**TO:** St. Francis Planning Commission  
**FROM:** Beth Richmond, Consulting Planner  
**SUBJECT:** Dalton River Villas Concept Review  
**DATE:** 6-11-2025 for 6-18-2025 meeting  
**APPLICANT:** Meadow Creek Construction (Mike Pomerleau)  
**LOCATION:** PID 32-34-24-24-0069  
**COMP PLAN:** Low Density Residential and Park/Open Space  
**ZONING:** R-1 Urban Low Density Detached Residential

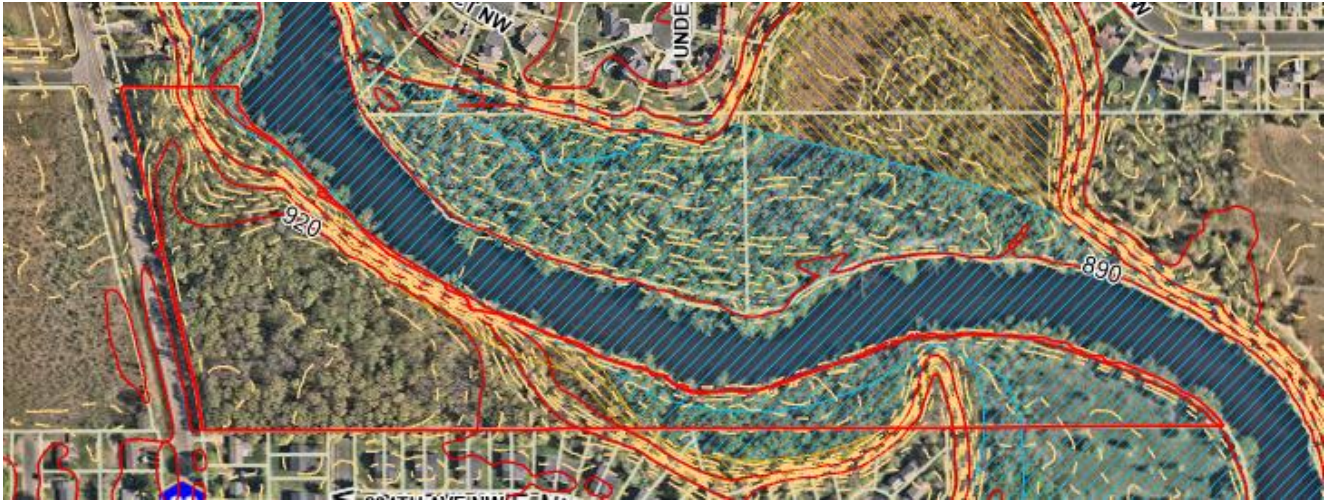
The concept proposes lots which are undersized in lot area, lot width, and which do not meet the front setback requirement for the uRRM overlay district. 8 of the proposed lots meet the R-1 lot area requirement of 10,800 sq. ft., while 6 lots meet the uRRM requirement of 12,150 sq. ft. None of the lots meet the required 90-ft. lot width of the uRRM – 15 lots are proposed to be 65 feet wide and 4 lots are proposed to be 55 feet wide. Variances or a PUD would be required in order to allow the flexibility shown on the concept. Because the site is within the uRRM overlay district and therefore would require DNR approval for any variance or ordinance amendment, the City has notified the DNR of the concept and requested their feedback. No comments have been received as of June 9.

An outlot is proposed along the Rum River which encompasses the floodplain area and the bluff. This outlot would also include the stormwater pond for the development. As part of a future application, the applicant would need to identify the owner for the outlot and provide the City access to the stormwater pond from the Woodbine St NW extension. The Planning Commission should discuss whether the City would be interested in owning this outlot. The City owns the open space along the river directly to the south of this outlot. It may make sense for the City to also take ownership of this outlot so that the two could be connected.

Street access to 16 of the 19 lots is proposed to come from an extension of Woodbine St NW. Woodbine St NW is currently constructed up to the south property line of the site. The concept shows the Woodbine St NW extension ending in a cul-de-sac. Staff and the applicant have discussed the possibility of connecting Woodbine St NW through to Ambassador Blvd NW instead of creating a cul-de-sac. Because Ambassador Blvd NW is a County Road, the County would have the final say on that possibility. Staff is supportive of either option but feels that the cul-de-sac option is more likely to be supported by the County based on Anoka County's street spacing guidelines.

Three of the proposed lots are shown to have access directly onto Ambassador Blvd NW. As an A Minor Collector, it is unlikely that Anoka County will allow additional access points onto Ambassador. If that is true, the applicant would need to adjust the concept to eliminate the access points onto Ambassador. This could be done through the use of shared driveways, lot reconfiguration, or the elimination of up to three lots.
